Mount Pleasant - Phase 1

Plans detailing the location of the roller shutters, fire shutter and automatic barriers

BOUYGUES MARK UP OF
ROLLER SHUTTERS
A.PETRASEVIC 21/04/2020

1 00 Upper Ground Level GA
Scale 1 : 200

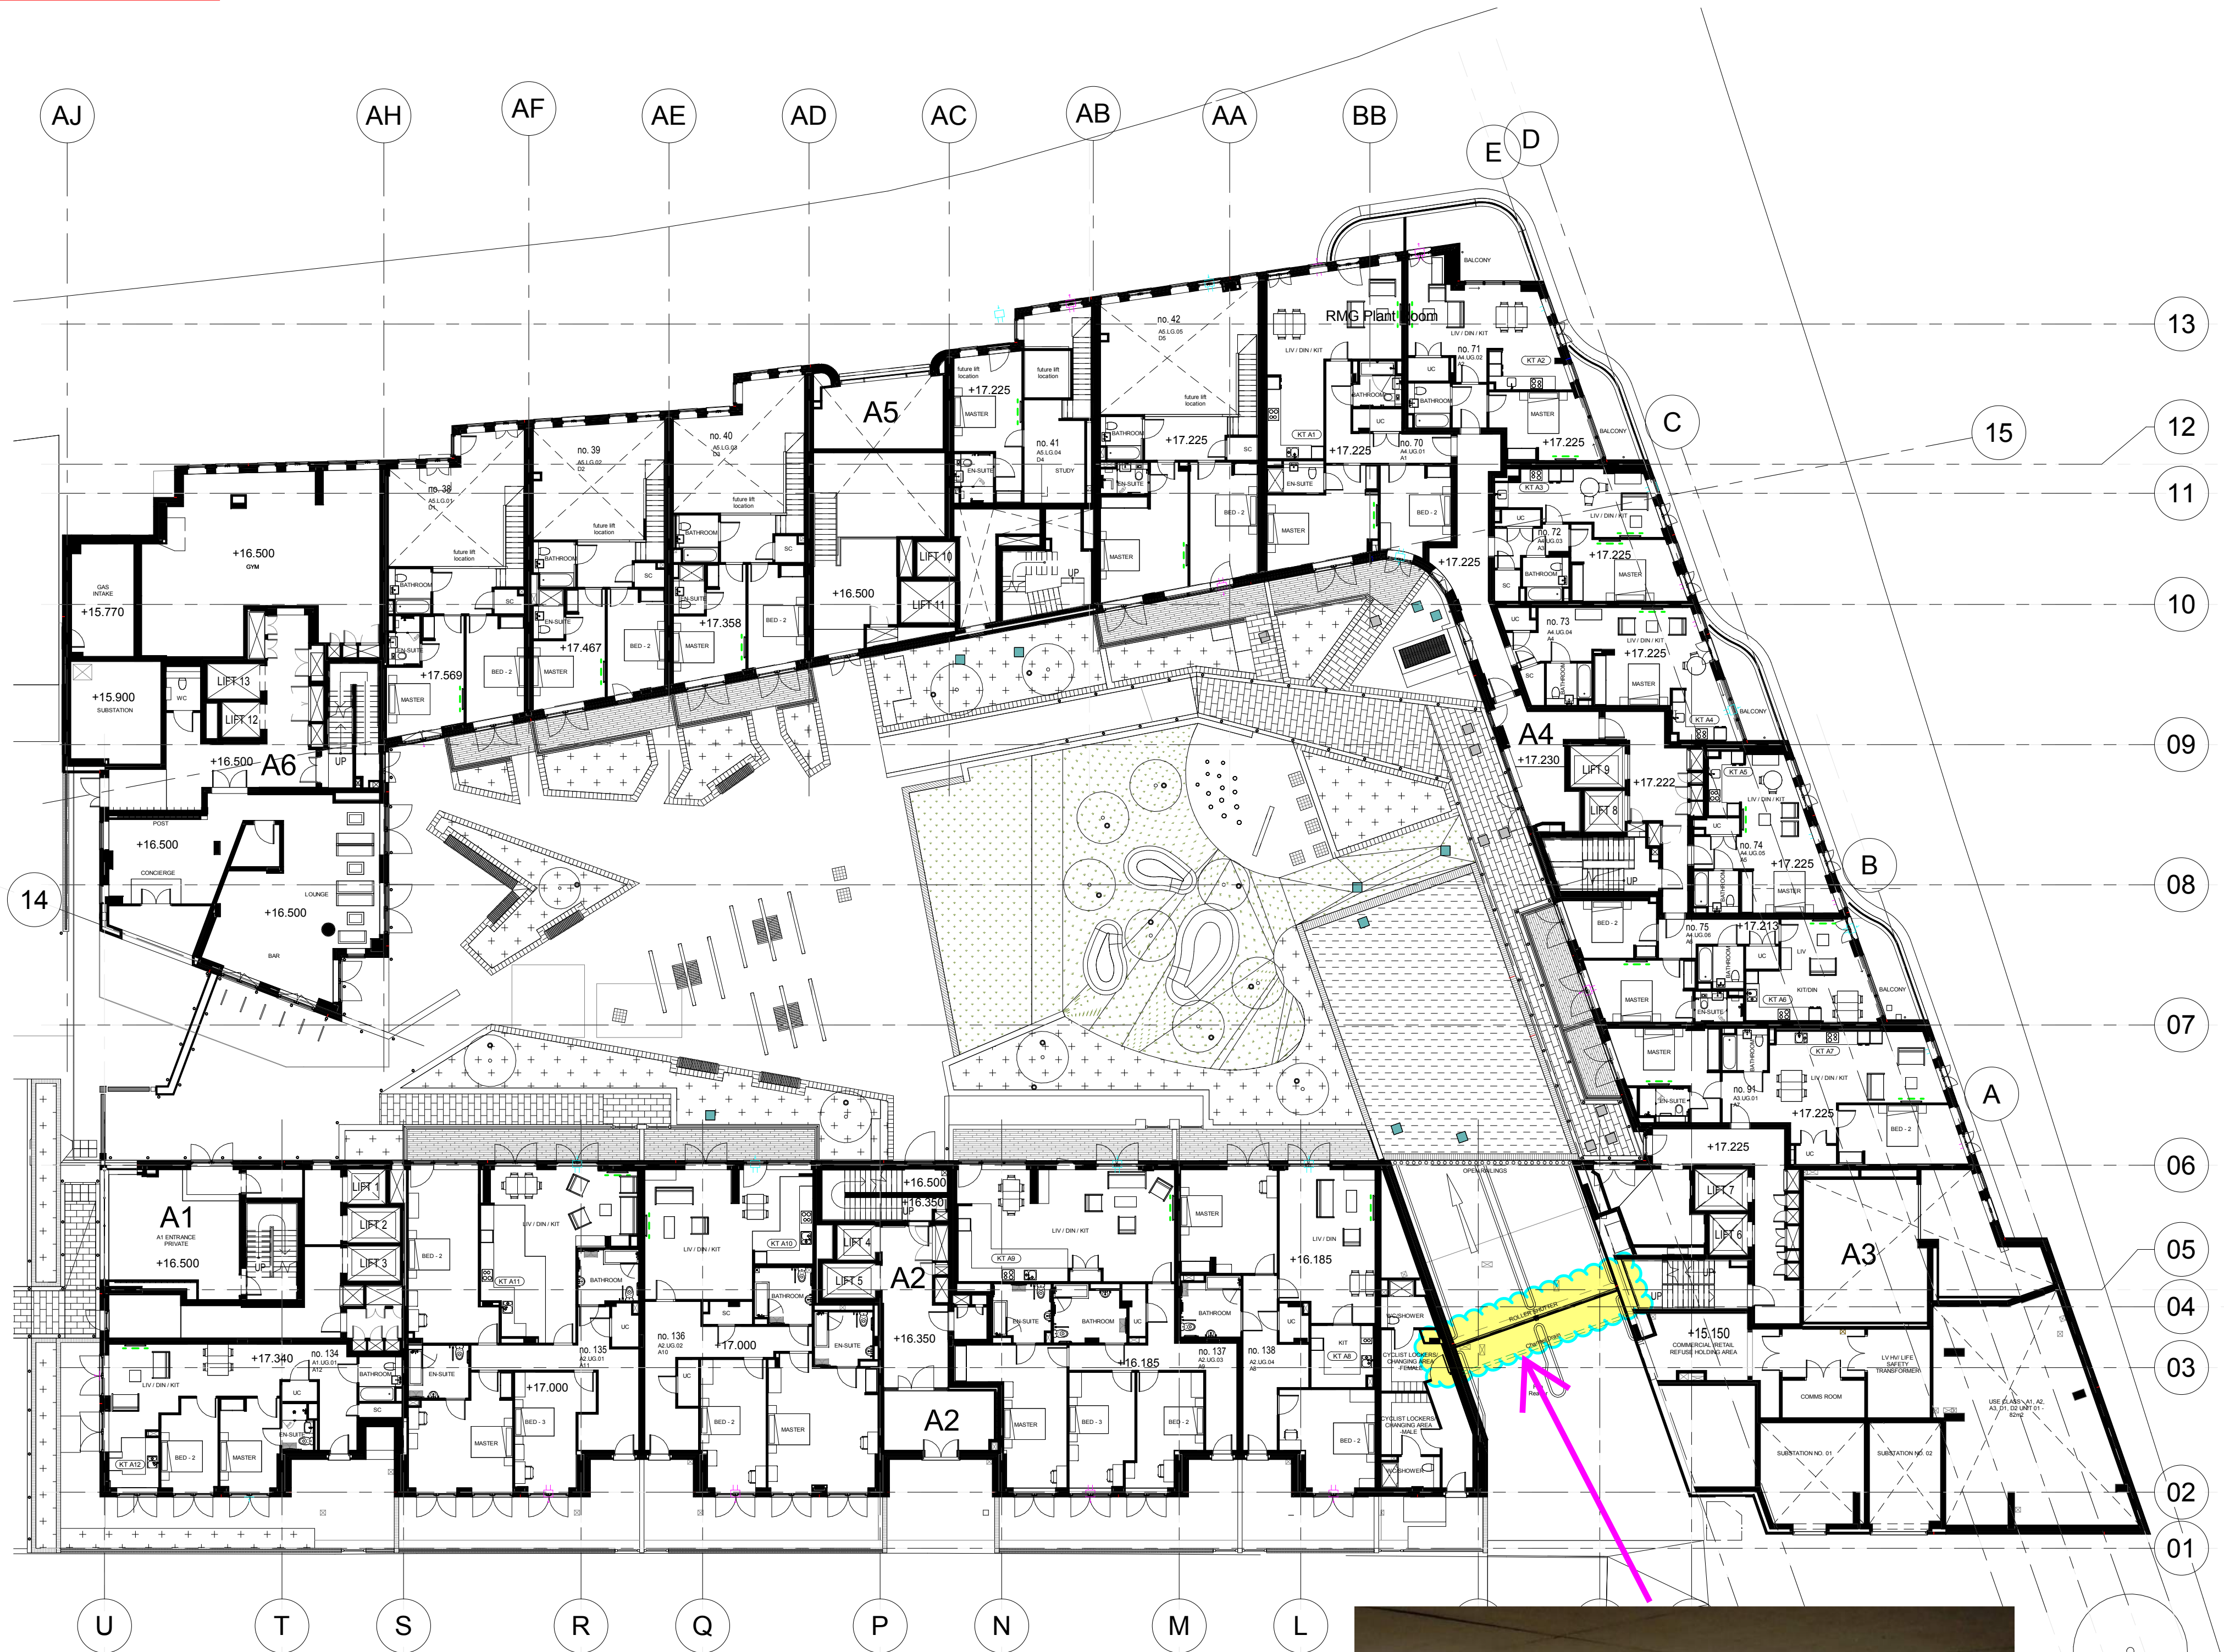
MAIN ENTRANCE ROLLER SHUTTER G1-HD

1 00 Lower Ground Level GA
Scale 1 : 200

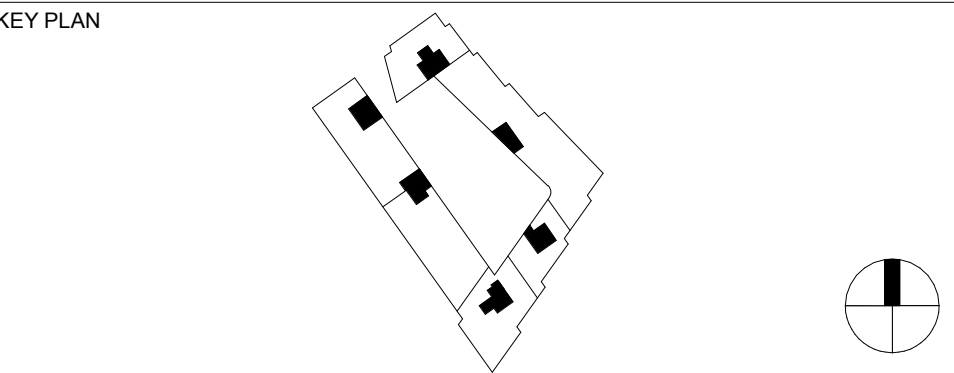
RESIDENTS PARKING ROLLER SHUTTER G1-HD

RMG PARKING BARRIERS - FAAC 620 AUTOMATIC BARRIERS

1 -01 Basement Level GA
Scale 1 : 200

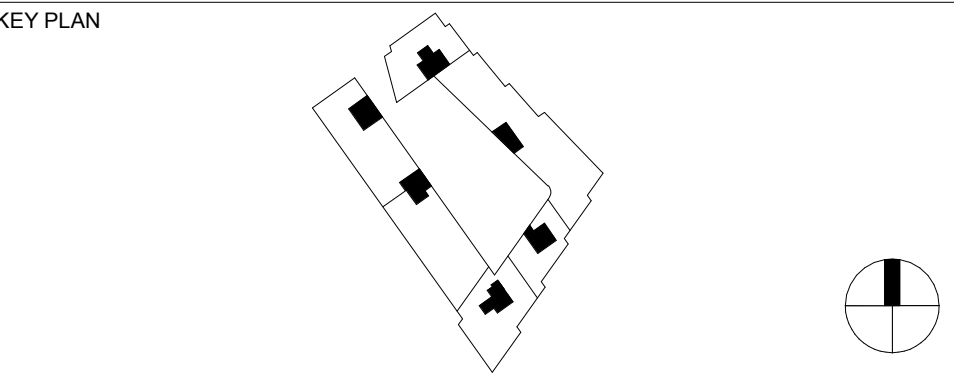
ENERGY CENTRE FIRE SHUTTER - FG01
